TECH BULLETIN 128

Product changes to crankcase, bearing covers and shaft protector for all 15 and 18 Frame plunger pumps

New Crankcase Style

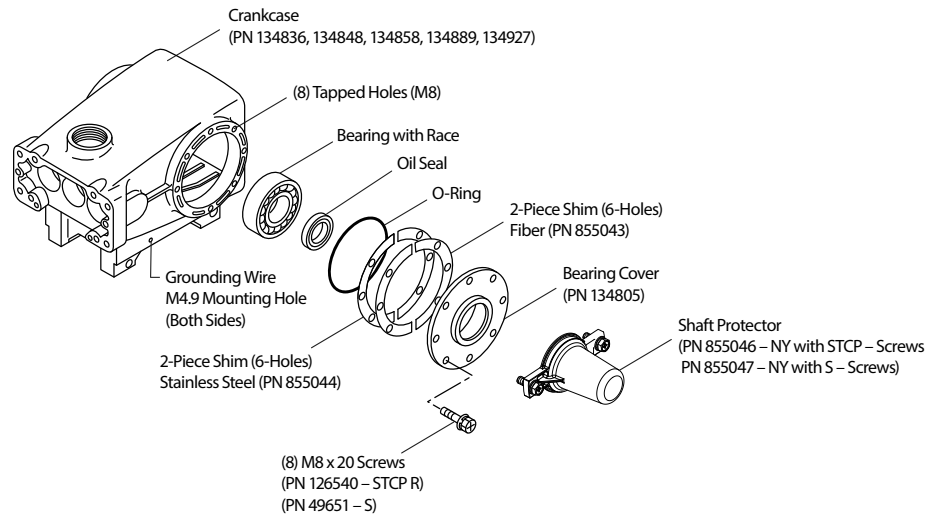
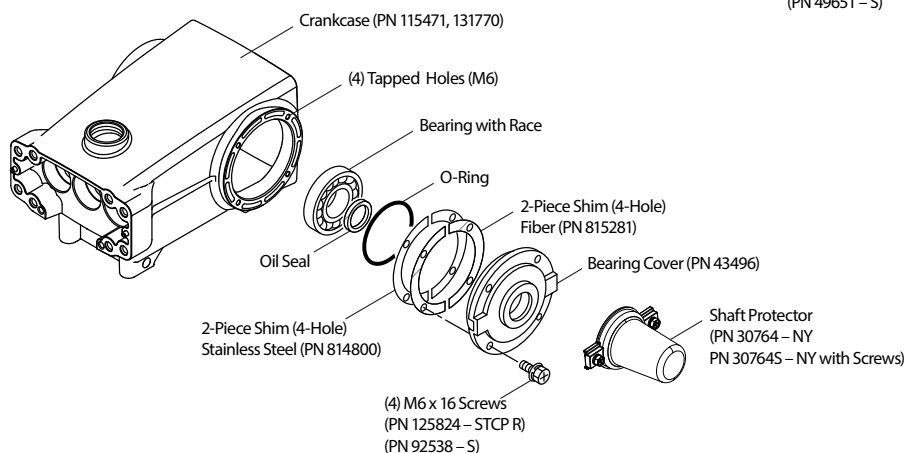
Changes have been made to the crankcase and mounting hardware to better support the weight of direct-drive bell housings. This affects all 15 and 18 frame plunger pumps with date codes/serial numbers after April 2019. (See reverse side for specific models)

- Crankcase bell housing mounting bolt holes number increased from four (4) to eight (8) to allow for proper strength to support weight of suspended pump.
- Bell housing mounting bolt quantity and sizes changed from four (4) M6 to eight (8) M8 bolts.
- Untapped M4.9-sized grounding wire mounting holes have been added on both sides of the crankcase.
- M4.9 ID hole (both sides) can be tapped to a M6 thread.

- Bearing cover bolt holes enlarged (four [4] x M9) to accommodate M8 bolt size.
- Shaft protector bolt holes enlarged (two [2] x M9) to accommodate M8 bolt size.
